MODIFICATION OF DEVELOPMENT APPLICATION – MINOR MODIFICATION – SECTION 4.55(1A) – 50 SELF CONTAINED SENIOR LIVING UNITS – 56-58 YAMBA ROAD & 4 FREEBURN STREET, YAMBA – LOTS 1 & 2 ON DP829279 AND LOT 11 ON DP556436 (Council Ref: DA2019/0331) (Our Ref: 2020-388)

The applicant seeks to make a 'minor modification' to the Clarence Valley Council's (**Council**) development consent granted on 25 October 2019 (Council Reference: DA2019/0331) pursuant to Section 4.55 of the Act.

ELEVATIONS 1

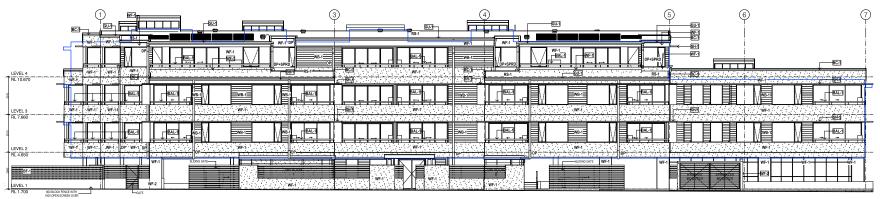
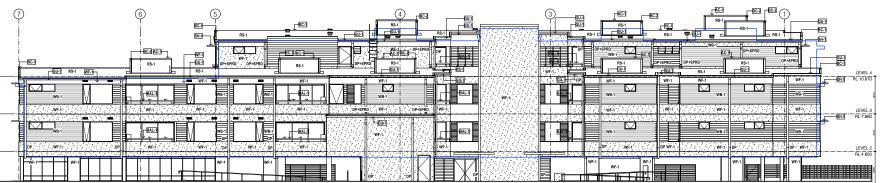
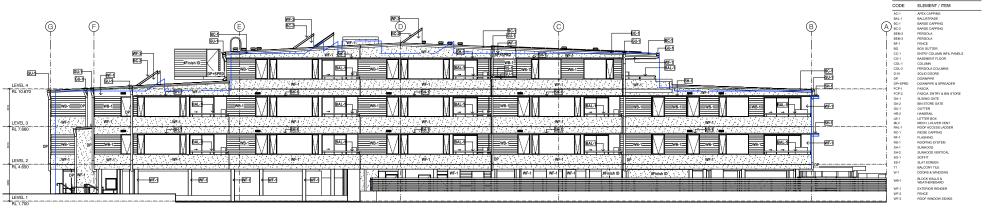
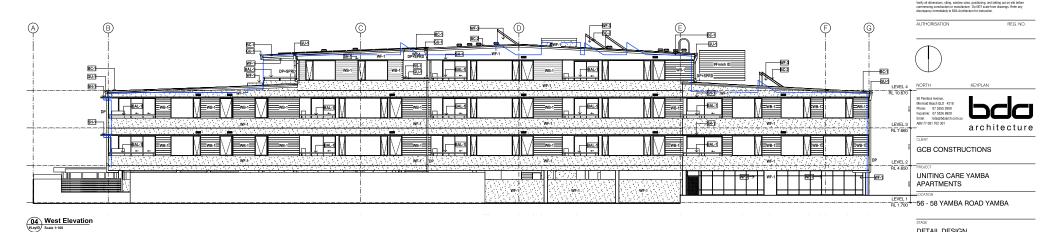
- The extent of the lift over-run depicted on the approval plans means that ultimately, it did not meet industry standards for servicing. Through on-going liaisons with various suppliers, the applicant has been able to ensure that a lift can be installed such that the lift over-run increases in height by 33cm (330mm) rather than the more standard 70cm (700mm)³. The overall height of the lift over-run will be 14.83m (up from 14.5m as originally approved).

As demonstrated on the plans submitted with this application, the marginal increase in height is associated with the 4 storey component of the built form. As a result, the increased height will not be readily perceived or visible by people at the ground level.

The modification to the development approval will be publicly notified. It is noted that the only change to the built form in terms of what was notified during the initial application assessment process is that marginal increase in building height. As mentioned, this increase equates to 25cm for the roof line of Level 4 and 33cm for the lift shaft.

Approved Plan	Proposed Plan					
Site Plan, Project Number 935, Dwg. No. 131 (Revision CC), dated 17 June 2019	Site Plan, Dwg. No. A1.101 (Issue B), dated 6 May 2021					
Level 1 Floor Plan, Project Number 935, Dwg. No. 131 (Revision CC), dated 17 June 2019	Level 1 – Ground, Dwg. No. A2.101 (Issue D), dated 28 May 2021					
Level 2 Floor Plan, Project Number 935, Dwg. No. 131 (Revision CC), dated 17 June 2019	Level 2, Dwg. No. A2.102 (Issue D), dated 28 May 2021					
Level 3 Floor Plan, Project Number 935, Dwg. No. 131 (Revision CC), dated 17 June 2019	Level 3, Dwg. No. A2.103 (Issue D), dated 28 May 2021					
Level 4 Floor Plan, Project Number 935, Dwg. No. 131 (Revision CC), dated 17 June 2019	Level 4, Dwg. No. A2.104 (Issue D), dated 28 May 2021					
Roof Plan, Project Number 935, Dwg. No. 131 (Revision CC), dated 17 June 2019	Roof, Dwg. No. A2.105 (Issue D), dated 28 May 2021					
Section A, East Elevation, Project Number 935, Dwg. No. 120 (Revision CC), dated 17 June 2019	Elevations 1, Dwg. No. A3.101 (Issue C), dated 6 May 2021
